AGENDA
President and Board of Trustees
Village of Arlington Heights
Board Room

Arlington Heights Village Hall
33 S. Arlington Heights Road
Arlington Heights, IL 60005
October 20, 2025
7:30 PM

- X. NEW BUSINESS
- A. Resolution Agreement – MAP CBA (2026) and MOU of Work Schedule for Patrol Bureau
 - B. 1920 N. Chestnut Ave. - Chestnut Woods Subdivision - PC#24-018 Preliminary Plat of Subdivision, Variations

- C. 4 W. Rand Rd. - Qargo Coffee - PC#24-023
Planned Unit Development Amendment, Special Use Permit, Variation
- XI. ADJOURNMENT

DESIGNED BY: SCO
PROJECT NO.: 2024-1920
DATE: 10/10/2024
SCALE: 1:10 (FULL); 1:20 (HALF)
SHEET 3 OF 5

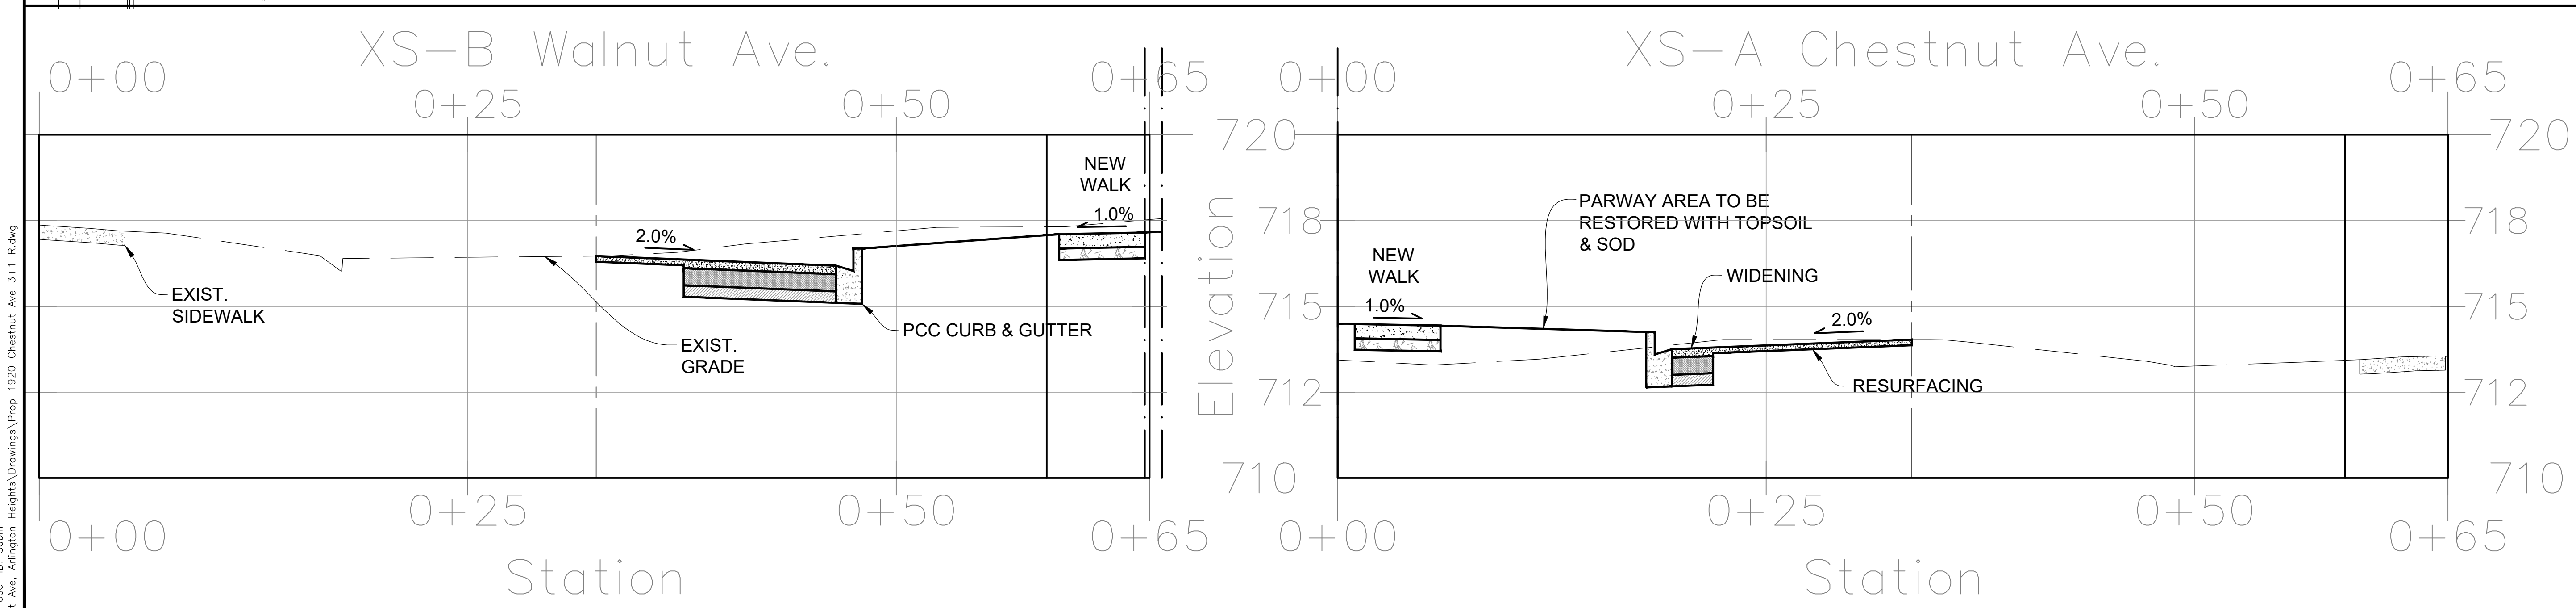
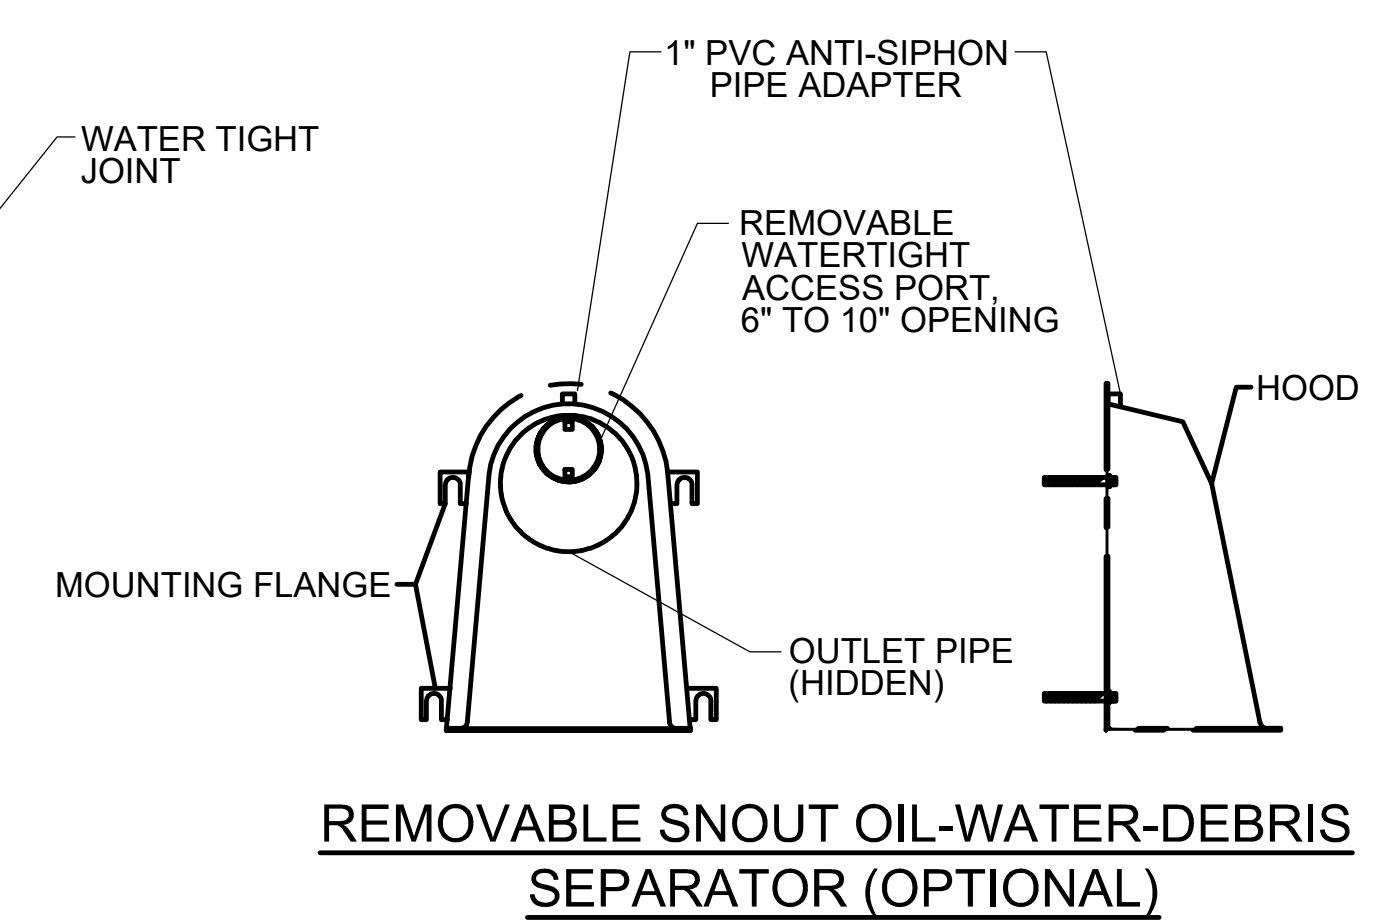
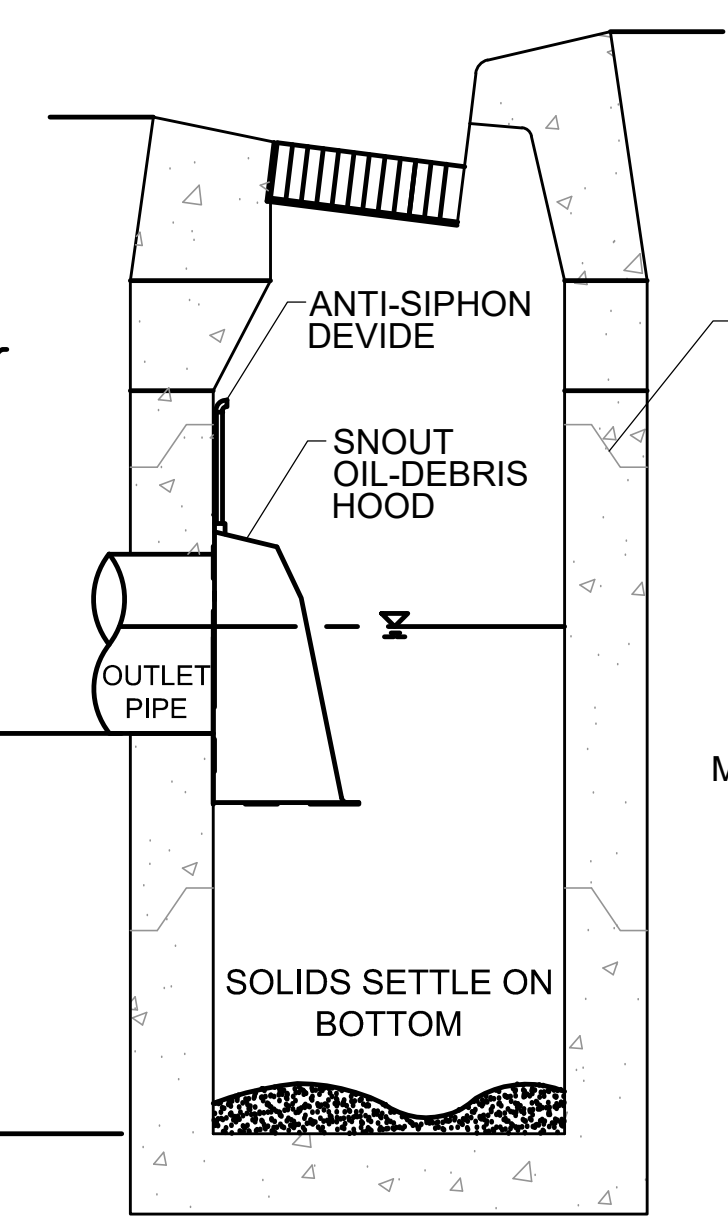
- a) The ROW Improvements shown on sheet C-5 is preliminary. Provide full civil drawings with elevations, dimensions, and cross sections. The pavement shall be resurfaced to the center of the roadway.

a) The ROW Improvements shown on sheet C-5 is preliminary. Provide full civil drawings with elevations, dimensions, and cross sections. The pavement shall be resurfaced to the center of the roadway.
IMPLEMENTED.

b. Provide a removable hood over the restrictor. NOTE 5 ADDED ON SHEET 4.

A1.01A

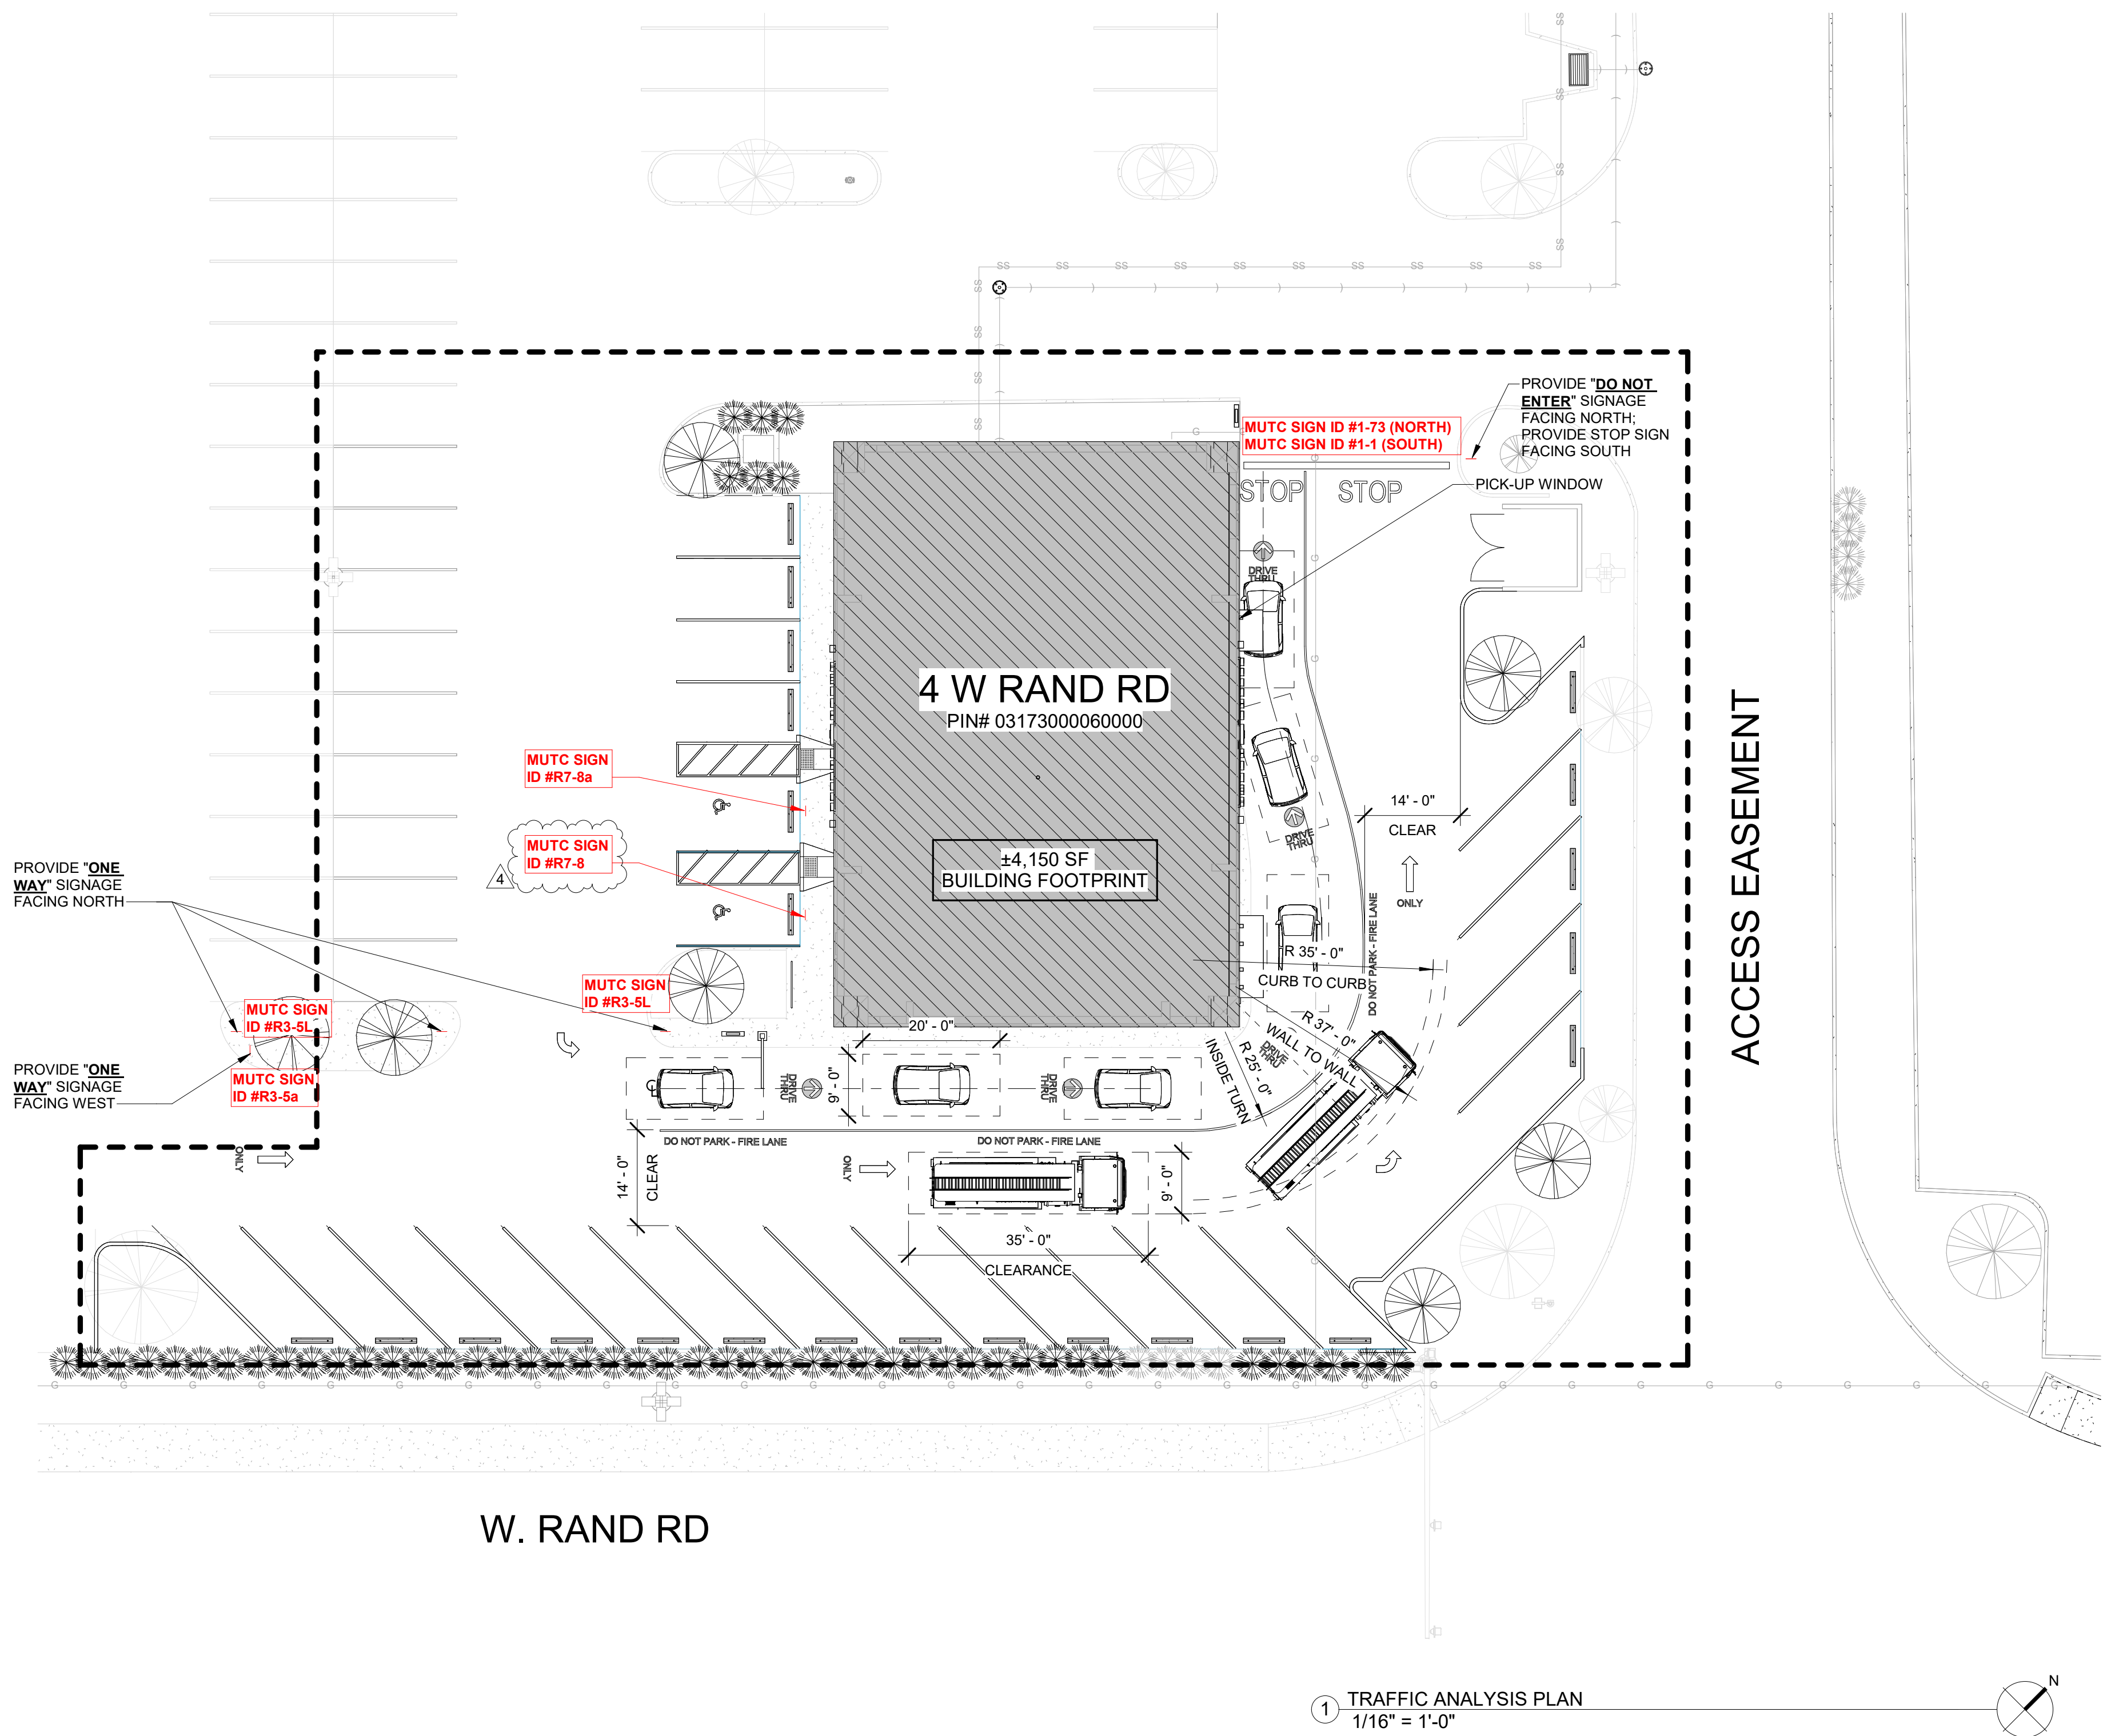
23		23.COMPLETE: Show one-way striping adjacent to the angled spaces.	Dan Osoba	Acknowledged.
24		24.INCOMPLETE: One-way signage is needed where the drive aisle changes from two- way to one-way. a. 2ND REVIEW: One-way signage needs to be provided at the southwest corner of the site where the drive aisle changes from two-way to one-way traffic.	Dan Osoba	Provided in revised sheet A1.01.

30		30.INCOMPLETE: Bicycle parking spaces are required with this application. Show the location and design of bicycle parking spaces (2 required) with your next submittal. Bicycle parking spaces shall comply with standards set forth in the Association of Pedestrian and Bicycles Professionals Bicycle Parking Guidelines Handbook. a. 2ND REVIEW: Bicycle racks were not provided or shown on the site plans for this submission.	Dan Osoba	Provided on revised sheet A1.01
END
